RANGELINE HAMILTON COMMERCIAL PARK **SUBDIVISION, RESUBDIVISION OF LOTS 6 & 7**

APPLICATION NUMBER 16 DATE October 1, 2020

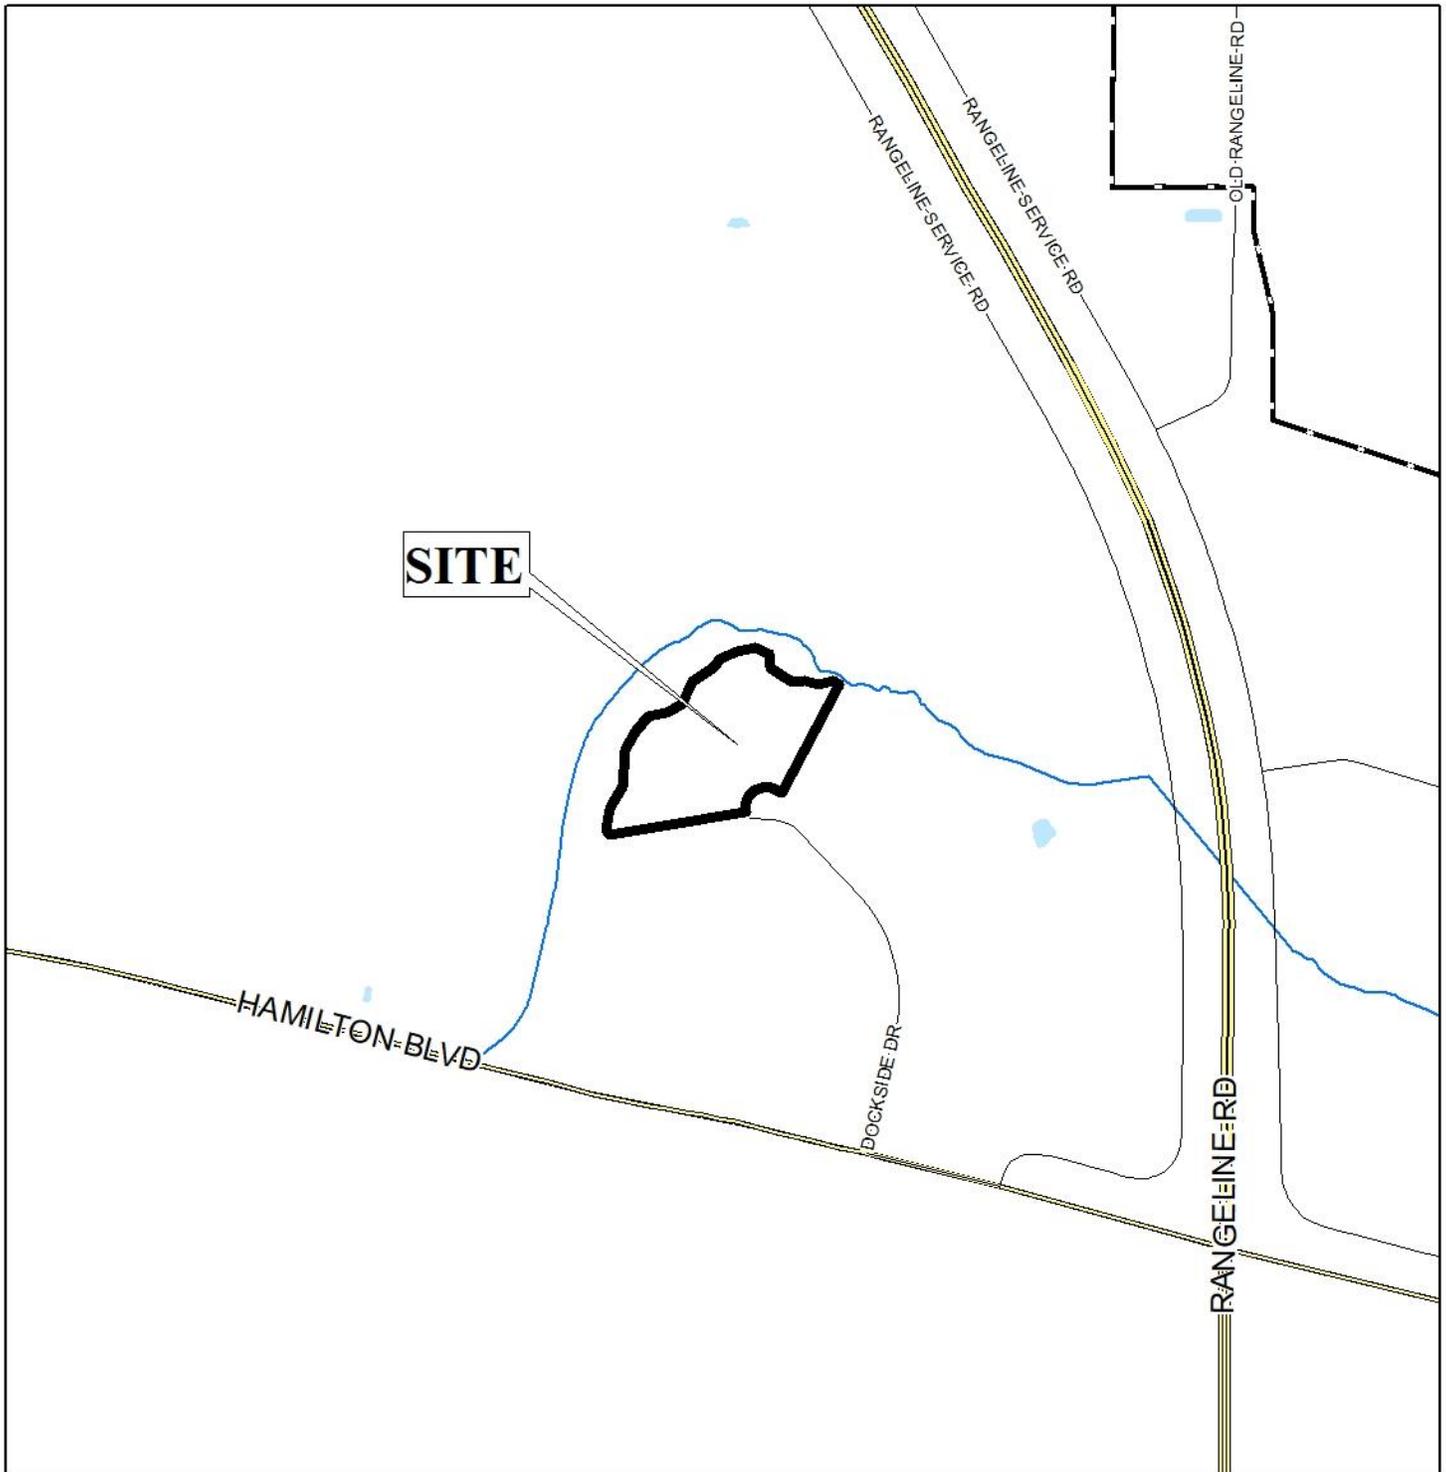
In accordance with the Subdivision Regulations, the proposed lot exceeds the minimum lot size requirement. As on the preliminary plat, the lot size label in both square feet and acres should be retained on the Final Plat, or a table should be furnished on the Final Plat providing the same information.

The proposed lot fronts Dockside Drive, a minor street with a 110'-diameter cul-de-sac fronting the subject site. The current requirement is for a 120'-diameter cul-de-sac; however, as the current diameter was the standard at the time of approval of Rangeline-Hamilton Commercial Park Subdivision, no dedication for further right-of-way should be required.

As on the preliminary plat, the 25-foot minimum building setback line along Dockside Drive should be retained on the Final Plat.

As per the Traffic Engineering comments, the lot is limited to two curb cuts with size, location and design to be approved by Traffic Engineering and conform to AASHTO standards. Any new on-site parking, including ADA handicap spaces, should meet the minimum standards as defined in Section 64-6 of the City's Zoning Ordinance. A note containing the Traffic Engineering comments should be placed on the Final Plat.

- 1) retention of the lot size label in both square feet and acres on the Final Plat, or the furnishing of a table on the Final Plat providing the same information;

- 2) retention of the 25-foot minimum building setback along Dockside Drive;
- 3) compliance with the Engineering comments: (*FINAL PLAT COMMENTS* (should be addressed prior to submitting the FINAL PLAT for review and/or signature by the City Engineer): A. Provide all of the required information on the SUBDIVISION PLAT (i.e. signature blocks, signatures, certification statements, written legal description, required notes, legend, scale, bearings and distances) that is required by the current Alabama State Board of Licensure for Professional Engineers and Land Surveyors. B. Provide and label the monument set or found at each subdivision corner. C. Show and label all flood zones. D. Show and label the MFFE (Minimum Finished Floor Elevation) on each lot that contains an AE, V, or X (shaded) flood zone designation. E. Add a signature block for the Owner, Notary Public, Planning Commission, Traffic Engineer, and City Engineer. F. Provide the Surveyor's Certificate. G. Provide the Surveyor's and Owner's (notarized) signatures. H. Add a note to the SUBDIVISION PLAT stating that as shown on the 1984 aerial photo (FLIGHT 24 - #95) LOT A will receive historical credit of existing (1984) impervious area towards stormwater detention requirement per Mobile City Code, Chapter 17, Storm Water Management and Flood Control) as follows: LOT A – NONE. I. Add a note to the SUBDIVISION PLAT stating that a Land Disturbance permit will be required for any land disturbing activity in accordance with Mobile City Code, Chapter 17, Storm Water Management and Flood Control); the City of Mobile, Alabama Flood Plain Management Plan (1984); and, the Rules For Erosion and Sedimentation Control and Storm Water Runoff Control. J. Add a note to the Plat stating that the approval of all applicable federal, state, and local agencies (including all storm water runoff, wetland and floodplain requirements) will be required prior to the issuance of a Land Disturbance permit. K. Add a note that sidewalk is required to be constructed, and/or repaired, along the frontage of each lot, or parcel, at time of new development or construction, unless a sidewalk waiver is approved. L. Add a note to the plat stating that all proposed detention facilities, common areas, and wetlands shall be the responsibility of the Property Owner(s), and not the responsibility of the City of Mobile. M. Add a note to the plat stating that all easements shall remain in effect until vacated through the proper Vacation process. N. Email a pdf copy of the FINAL SUBDIVISION PLAT and LETTER OF DECISION to the Permitting Engineering Dept. for review at land.disturbance@cityofmobile.org prior to obtaining any signatures. No signatures are required on the drawing. O. After addressing all of the FINAL SUBDIVISION PLAT review comments provide the ORIGINAL (with all signatures except for the Planning Commission, Traffic Engineering, and City Engineer), one (1) copy, and a transmittal letter to the Engineering Permitting Department. They can be dropped off at 205 Government St. or mailed to PO Box 1827, Mobile, AL, 36633.);

- 4) placement of a note on the Final Plat stating the Traffic Engineering comments: (*Lot is limited to two curb cuts with size, location and design to be approved by Traffic Engineering and conform to AASHTO standards. Any new on-site parking, including ADA handicap spaces, should meet the minimum standards as defined in Section 64-6 of the City's Zoning Ordinance.*);
